To: Diane Sugimura
From: Council President Sally Clark
Date: October 18, 2013
Subject: **Fixing Lowrise zoning**

RE: **Commission Comments on Lowrise Multifamily Code Corrections**

Subject: March 20, 2010 Special COBE Meeting: Updates to Multifamily Zones

Diagram 1: Illustration of a partially buried first floor, for which a height exception of four additional feet is proposed

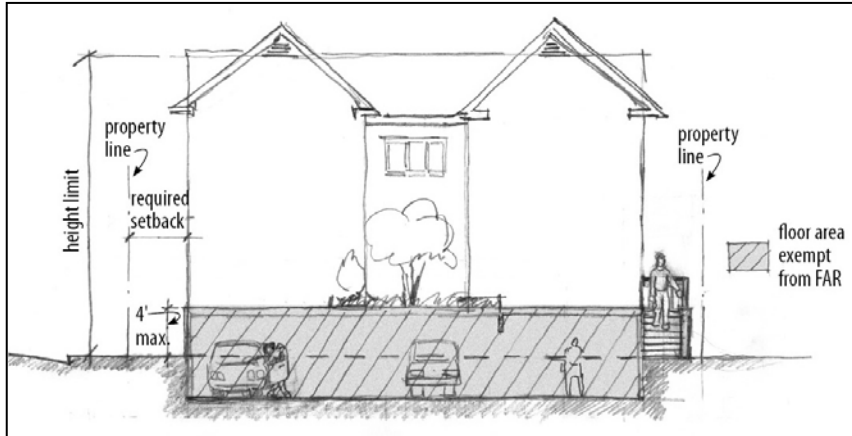
The second proposed option for rowhouses and townhouse to gain additional height is to allow an additional four feet of wall height, so that the main floor of the structure can be elevated above street level without the loss of an upper floor. This provides more privacy for the units, avoiding the need for continuous fencing at the front lot line, and encourages better design features, such as front stoops. It also provides flexibility for sloping sites. A rowhouse or townhouse taking advantage of this exception would be limited to three floors. Diagram 1 below illustrates this idea, which has already been put in place in Midrise zones.

Diagram 2: Options for townhouse and rowhouse height exceptions in LR3 zones

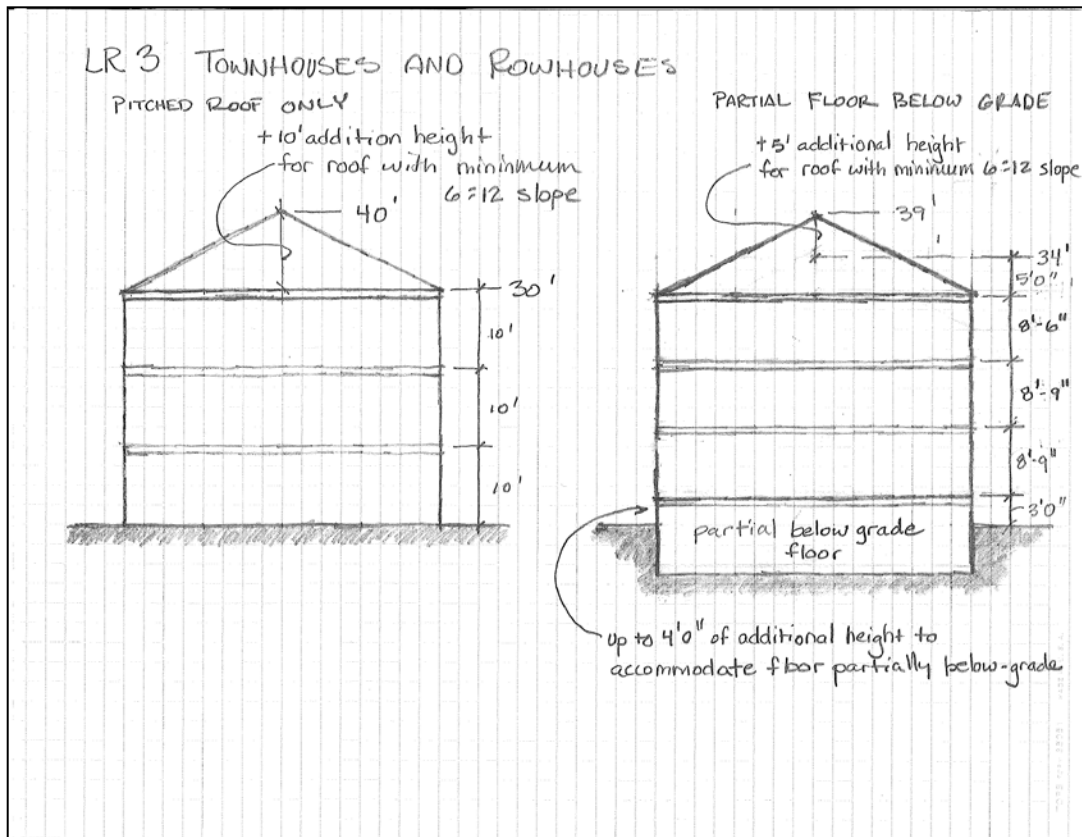
In addition to the exception for the partially buried first floor, we recommend that a pitched roof exception be provided. However, if the two exceptions are combined, the pitched roof would only allow five additional feet, not ten. Diagram 2 illustrates both proposed options.

Diagram 3: Proposed Height for Apartments outside of designated growth areas

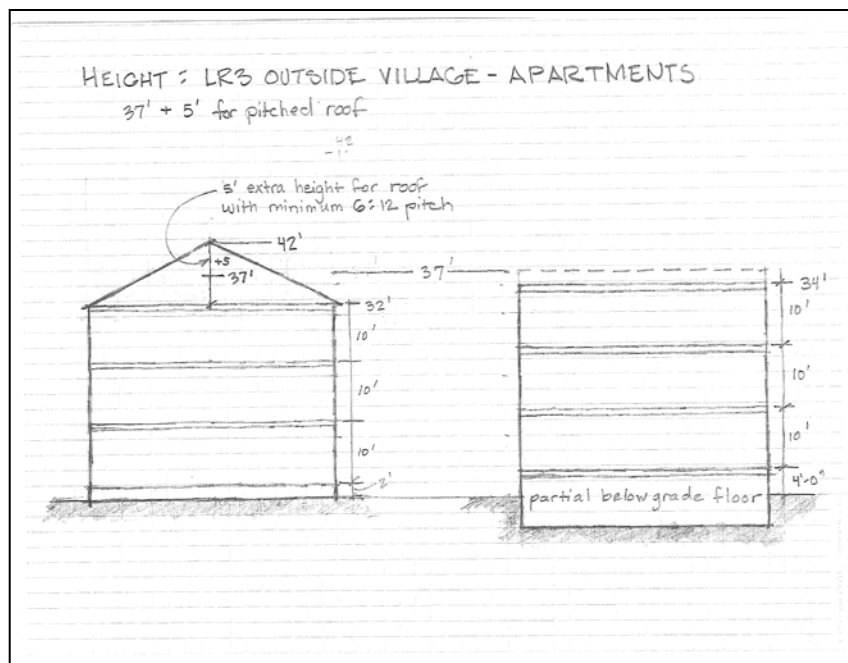
Outside of designated growth areas, the proposed base height limit for apartments (measured from grade to the top of the wall) would result in a seven foot height increase for L3 zones, and no change for L4 zones. Inside designated growth areas, our recommendation would result in a base height increase in current L3 zones of ten feet, or 14 feet if the proposed four foot increase for a partial floor is included. For L4 zones, it would be an increase of three feet, or seven feet if the proposed four foot increase for a partial floor is included. Diagrams 3 and 4 below illustrate options for apartment development inside and outside of designated growth areas.

Diagram 4: Proposed Height for Apartments inside designated growth areas

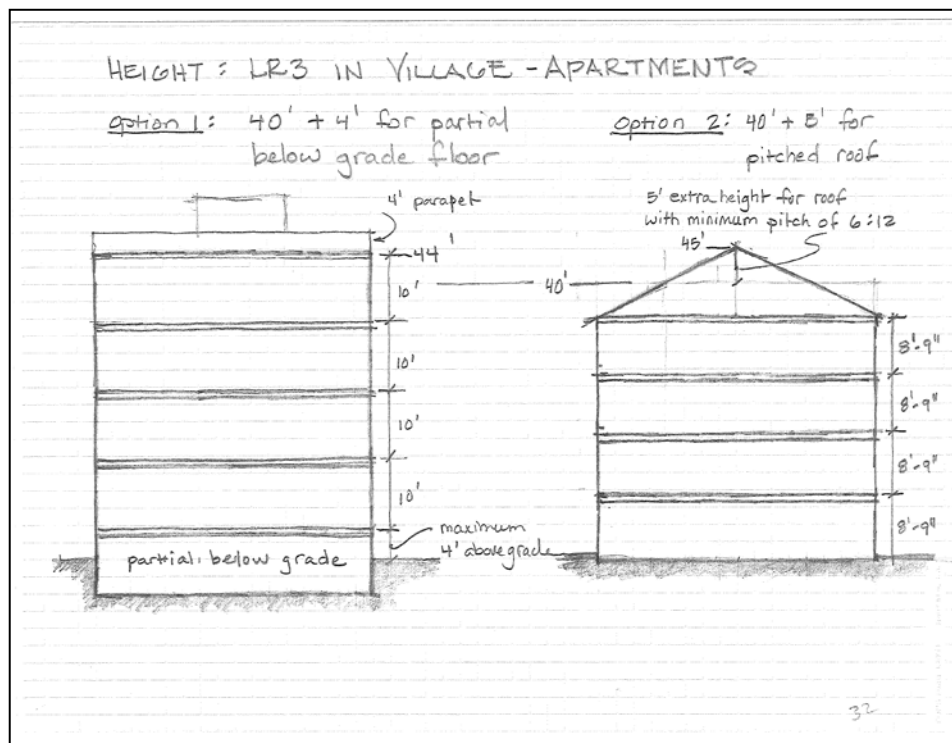
These recommendations support the goal of making it possible again to build four-story apartment buildings in the densest lowrise multifamily zones, while encouraging desirable design features. The proposed height and FAR limits would work together to allow somewhat larger buildings in LR3 zones inside designated growth areas.

The Planning Commission supports increasing the height limit in the current L3 zones to at least 37 feet, although they have not had a chance to comment on the idea of differentiating between housing types, or areas inside and outside designated growth areas.
